Change of socket material and integration of V-Lock cord retaining feature as standard.

Product Change Notification						C20F snap-in and screw-on rear version PCN	
owner	creation date	release date	released by	change order no	rev	page	D10-015-728
sariogar	09.05.2017	30.10.2017	blumhe	2010167	A	1 of 2

Old product appearance	New product appearance
<p>Snap-in mounting from front side</p>  	<p>Snap-in mounting from front side</p>  
<p>Screw-on mounting from rear side</p>  	<p>Screw-on mounting from rear side</p>

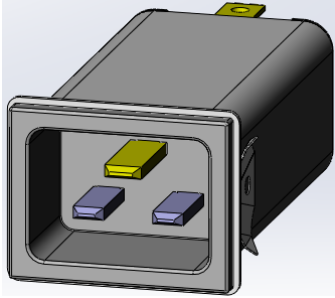
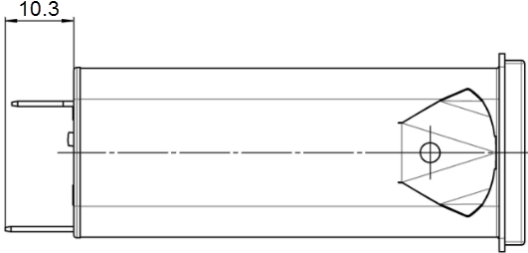
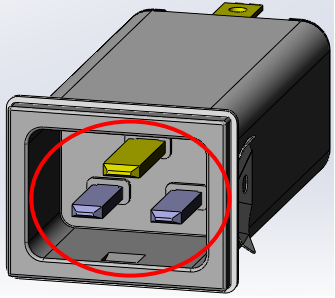
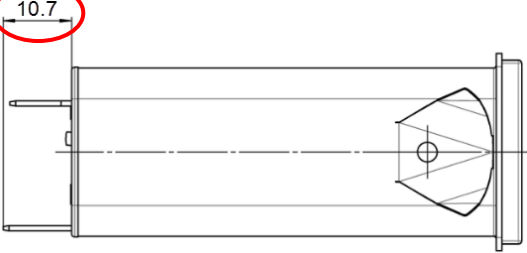
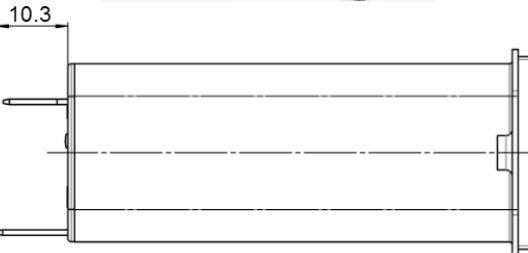
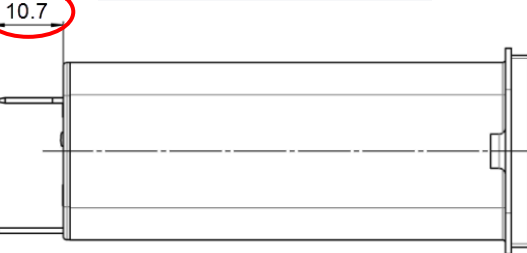
- Socket material change from PA6 to PA66/6 to pass the enhanced requirements of glow wire test acc. to IEC 60695-2-12 and -13
- V-Lock cord retaining integrated as standard feature (not an option anymore)

Form	Yes	Socket has notch for V-Lock cord retaining, new form on extended socket dimension and socket base.
Fit	Yes	Installation depth is 0.40 mm extended.
Function	Yes	V-Lock feature is standard (not an option anymore)
Production Site	No	There is no change of the production site
Product Label	No	No label change
Customer Action	Yes	PE-Terminal is 0.4mm longer. Check installation depth in the application. Change SCHURTER part number if affected.
